**ENVIRONMENTAL PROTECTION
AGENCY**
40 CFR Part 63
[EPA-HQ-OAR-2018-0794; FRL-6716.3-02-OAR]
RIN 2060-AV53
**National Emission Standards for
Hazardous Air Pollutants: Coal- and
Oil-Fired Electric Utility Steam
Generating Units Review of the
Residual Risk and Technology Review**
AGENCY: Environmental Protection Agency (EPA).

ACTION: Final rule.

SUMMARY: This action finalizes amendments to the national emission standards for hazardous air pollutants (NESHAP) for the Coal- and Oil-Fired Electric Utility Steam Generating Units (EGUs) source category. These final amendments are the result of the EPA's review of the 2020 Residual Risk and Technology Review (RTR). The changes, which were proposed under the technology review in April 2023, include amending the filterable particulate matter (fPM) surrogate emission standard for non-mercury metal hazardous air pollutants (HAP) for existing coal-fired EGUs, the fPM emission standard compliance demonstration requirements, and the mercury (Hg) emission standard for lignite-fired EGUs. Additionally, the EPA is finalizing a change to the definition of "startup." The EPA did not propose, and is not finalizing, any changes to the 2020 Residual Ri

Figure 1. 2022 Daily and 30-Day Rolling Average Hg Emission Rates (lb/TBtu)

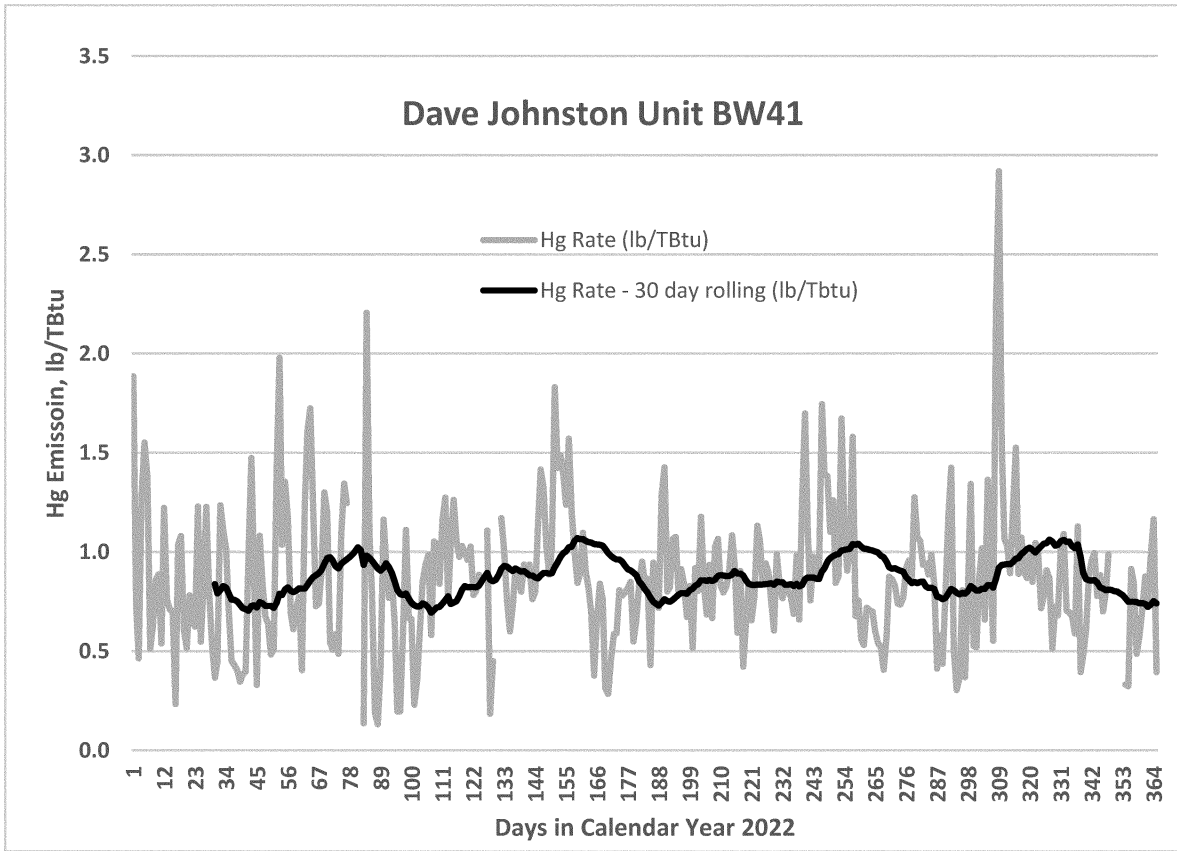
variability. For example, in figure 1 (a graph) of this document, the 2022 Hg emissions from Dave Johnston unit BW41, a unit firing subbituminous coal, are shown. The graph shows both the

however, the 30-operating-day rolling average is consistently below the emission limit (the annual average emission rate is 0.9 lb/TBtu).

Figure 2. Daily and 30-Day Rolling Average Hg Emission Rates (lb/TBtu) from Leland Olds Unit 1, lignite-fired EGU in North Dakota.

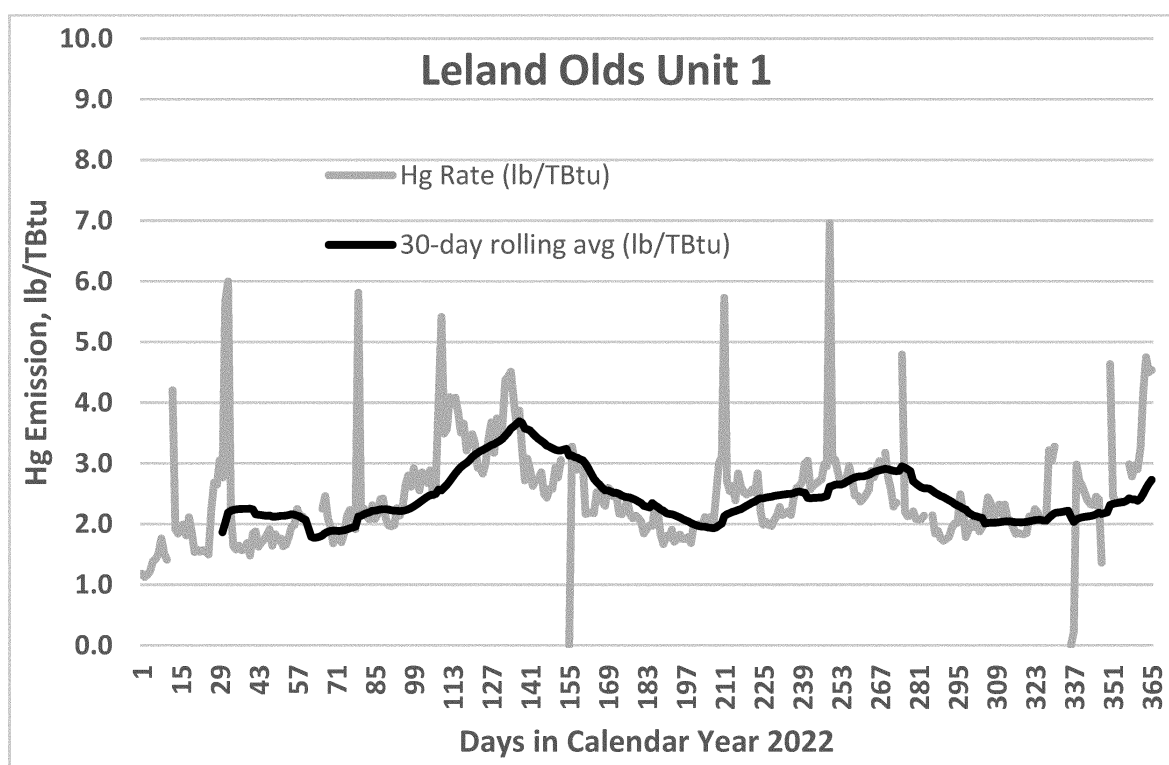
A similar effect can be seen with the 2022 daily and 30-operating-day rolling average Hg emissions from Leland Olds

unit 1, an EGU firing North Dakota lignite, shown in figure 2 of this document.
